1. Fields-Brown Subdivision; KPB File 2025-113
Peninsula Surveying / Fields
Location: Scout Lake Loop Road & Fields Road
Sterling Area

## ITEM #1 - PRELIMINARY PLAT Fields-Brown Subdivision

KPB File No.	2025-113
Plat Committee Meeting:	August 25, 2025
Applicant / Owner:	Ike S. Fields of Sterling, Alaska
Surveyor:	Jason Schollenberg / Peninsula Surveying, LLC
General Location:	Scout Lake Loop Road, Fields Road, Floodplain Avenue

#### STAFF REPORT

#### FIELDS-BROWN SUBDIVISION

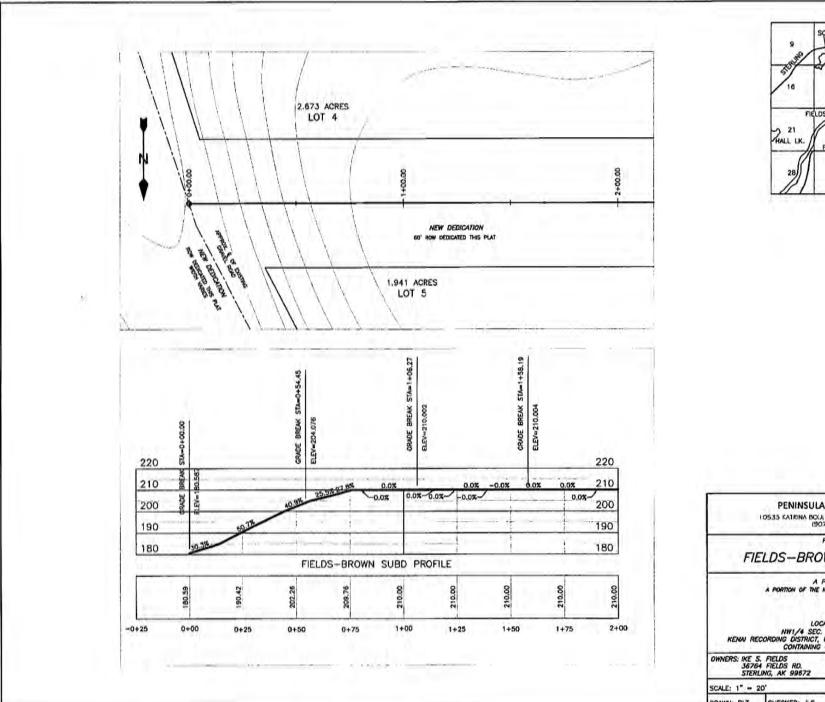
The proposed plat is dedicating Eastside Street on the east side of the plat, appearing to be located along an existing gravel road. The proposed right-of-way varies from approximately 156.85-feet at the north to 60-feet at the south. The approximate centerline of the existing gravel road is labeled on the plat. **Staff recommends** the surveyor locate the centerline of the road and allocate 30-feet to the west of the centerline for the east lot lines of Lots 4, 5 & 6. To the east of the centerline, evaluation of the limits should be considered and extension of the northwest line of Lot 7 north to occupy some of the land. If an additional lot is considered possible a revised plat would need to be resubmitted along with any exception needed. The Road Department Director is concerned with the road being off center to the area of the right-of-way, staff recommends the surveyor consider the previous recommendation or offer another.

Willowwood Circle is proposed to be dedicated by this plat, providing access to proposed Lots 2 through 5. The Roads Director is concerned with the design o Willowwood Circle. The entrance portion of the road exceeds the 4% grade limit within the first 100 feet of the intersection per KPB Code 14.06.160(A). Staff recommends the surveyor reconsider the location of the of the cul-de-sac for better slope grades at the entrance.

The Addressing Officer has denied the proposed street names of Willowwood Cir and Eastside St, as they both contain words from the prohibited list and the cul-de-sac suffix should be "Court." **Staff recommends** the surveyor and owner coordinate with the Addressing Officer, Rhealyn Pace, and determine appropriate road name.

To help reduce driveway entrance / exit traffic along Scout Lake Loop Road, **Staff recommends** a plat note be added stating Lot 6 should have interior access only,

A 66-foot section line easement is located on the west with 33-feet on either side of the section line. **Staff recommends** the surveyor continue the label for the section line easement to the north and south.

According to KPB GIS Imagery, a fence and possible structure encroach into the dedication of Fields Road. **Staff recommends** the surveyor confirm the location of improvements. If encroaching into the proposed dedication, evidence of removal of the encroachments into the dedication will need to be provided prior to finalization and recording of the plat. if not encroached in to the dedication, an exception to KPB 20.30.240 Building Setbacks will need to be requested or a Building Setback Permit submitted.

There also appears to be structures shown on the drawing in the southwest crossing the property line into the adjacent land. The purchaser of Tract A has spoken to staff about the issue and the current owner of the adjacent land is going to provide an easement permitting the structures to remain as located and have a buffer area around

- Modify the KPB File Number to 2025-113.
- Modify Plat Note numbering starting at 11 and on should be reduced one number
- o Remove plat notes number 14 and 15 from the final plat.

Increase 20' ROW dedication for Fields Rd to 30'

- Label ROW name and width to the west, Bradford Road 60'
- Modify label for Fields Road label adjacent to K1439 to a public road easement with document number 2020-007022-0
- N. Apparent encroachments, with a statement indicating how the encroachments will be resolved prior to final plat approval;

KPB GIS imagery shows a fence and possible structure located in the proposed 30-foot dedication of Fields Road. Confirmation of the removal of the encroachments will need to be provided.

A PROFILE OF
A PORTION OF THE NEW CUL-DE-SAC DEDICATION

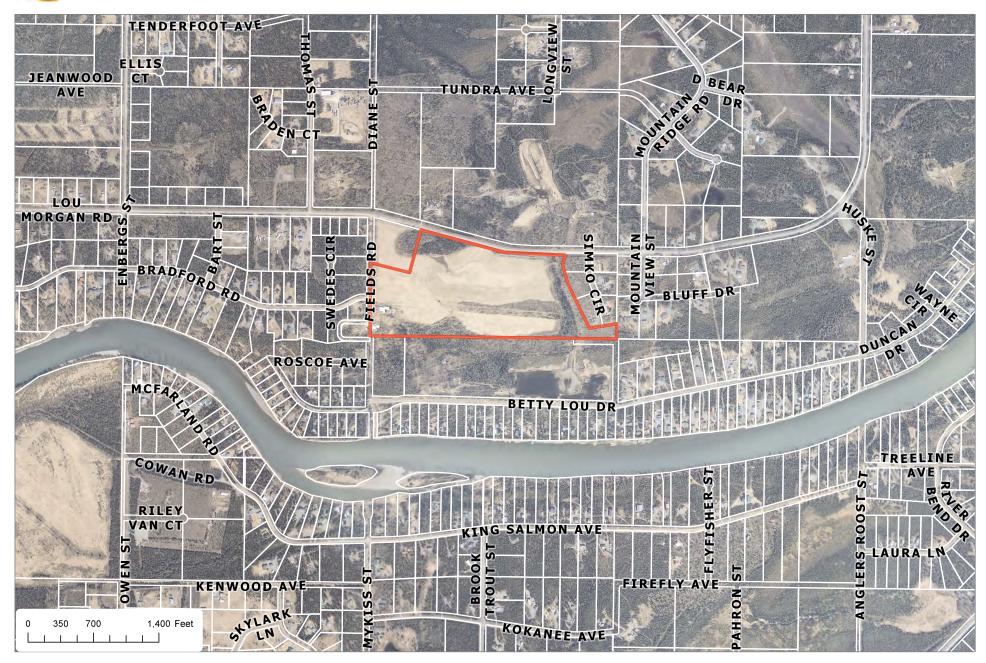
KPB Roads Dept RSA review	Out of Jurisdiction: No
	Roads Director: Uhlin, Dil Comments: Flood Plain Ave. ROW should be dedicated on the South East portion of the property. The Eastside St. ROW dedication exceeds the 60 ROW standard and would leave the existing road traveling surface off center to the ROW. The Fields Rd. ROW on the east side of the property should be dedicated. There are structures in what would be the dedicated ROW. The grades on Willowwood Cir are too steep and need to be addressed. KPB Code14.06.160(A) grade can be "no more than four percent within 100 feet of any intersection.
SOA DOT comments	No Response
